October 18, 2017

Re: City of Schenectady Bike Infrastructure Master Plan

Figure 4. Shared Use Path on Separated Right of Way, from 2000 Schenectady Urban Bike Master Plan

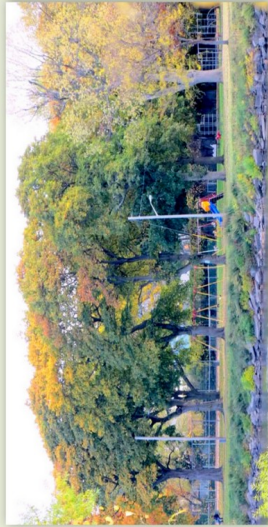
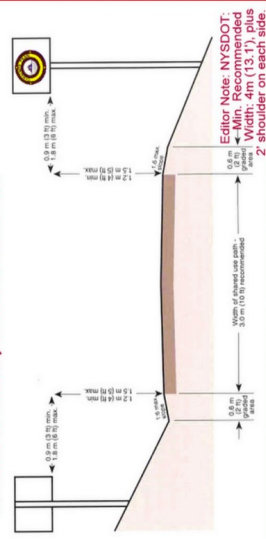
## a shared-use path in Riverside Park?

Above: Minimum Requirements: 10-ft width; 2-ft graded shoulders; 3-ft clearance for signs, trees, etc.

The current AASHTO guidelines, followed by NYS DOT, call for shared-use paths wider than 10' when 30% of the users are pedestrians. But, even with the 10-ft minimum, the required 2-ft wide graded shoulders on each side would mean removing two rows of the grandest trees in the Park. The photos in this collage show the size and beauty of those trees, which add much more than shade and color to the Riverside Park experience.

## TREASURED TREES AT-RISK

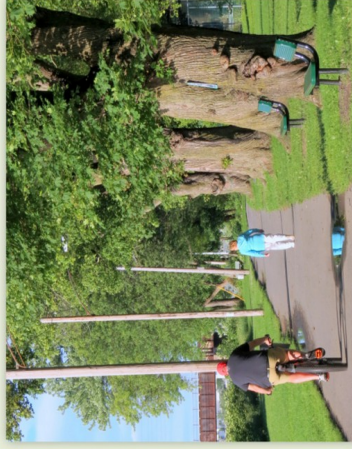
below: trees along the south side of path

above: utility poles along north side of path

above: trees & poles along north side of path

above: shrubs, curbs and bricks at the Esplanade would also need to be removed to add shoulders

Can a two-way bike-ped trail through Riverside Park co-exist safely with current uses?

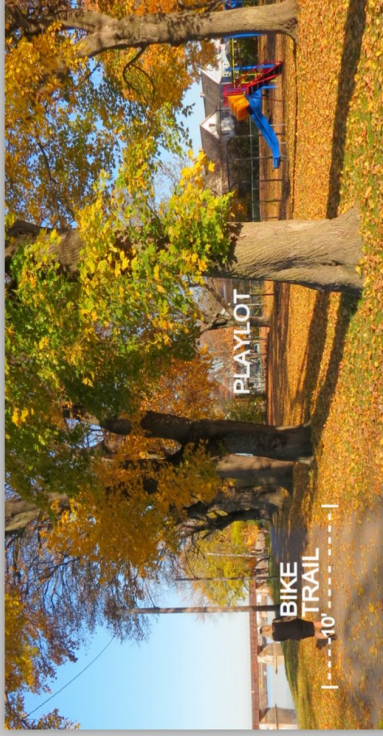
It is the only path or trail in this narrow, 6-acre Park, which is often praised for its slow pace & tranquility

- Fog often obscures vision.
- Trees & poles make adding required buffers impossible..

The trail is within 10 yards of a Kiddie Play Lot, with no physical barrier.

As the only hard surface, it is used for baby strollers, hopscotch, puddle-jumping, elders with walkers, wheelchairs, and more..

The west entry/exit is at a blind intersection with Washington Avenue
